BLM SCALAR FIX -Based on findbhudda's original design:
<http://www.midibox.org/dokuwiki/doku.php?id=findbhudda>

Corrected blm-scalar v1.1.brd below & attached: [blm-scalar_v1.1.zip](#)

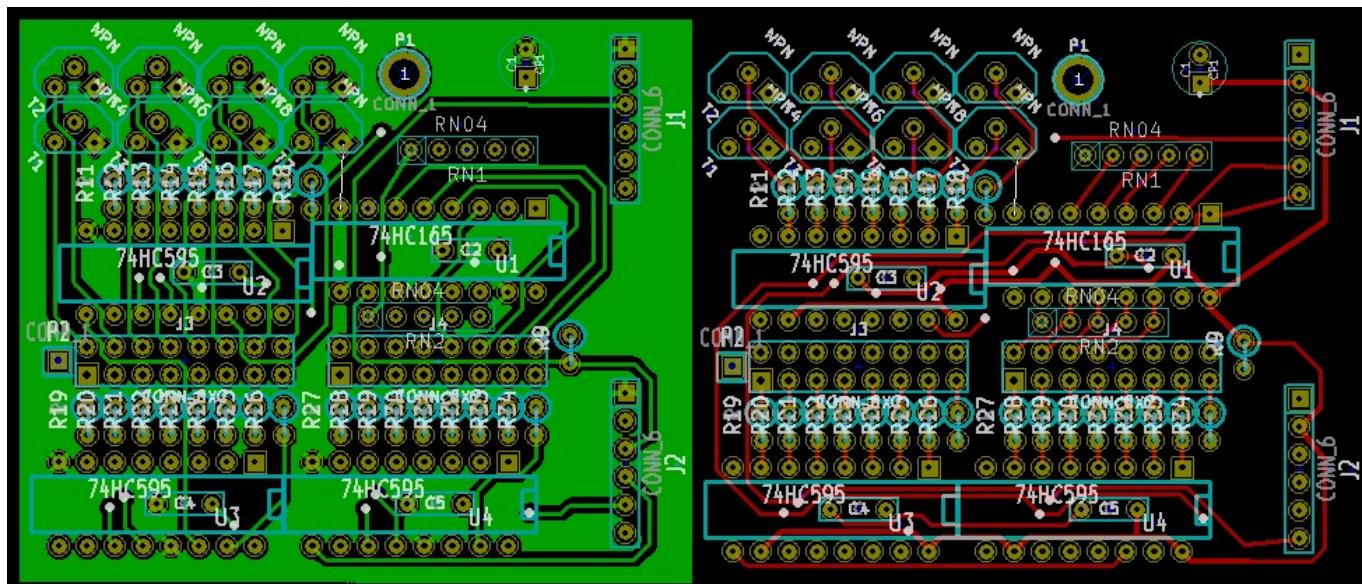
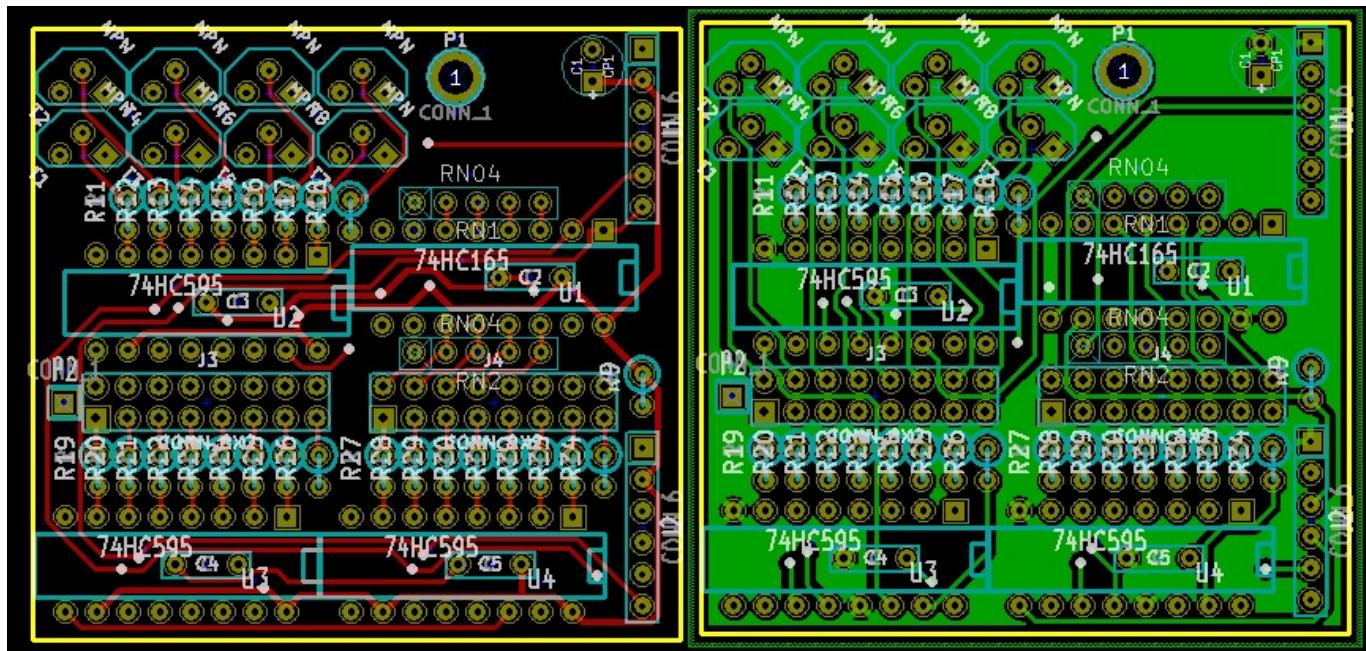
- blm-scalar.* contain an error. Pins I4-I7 are mirrored. This is easily fixed with a connector modification, and the blm-scalar module seems to work as intended.
- blm-scalar v1.1 attempts to fix this error. Moved connectors J1, J2 & Resistor Net 1 to make room for corrections.
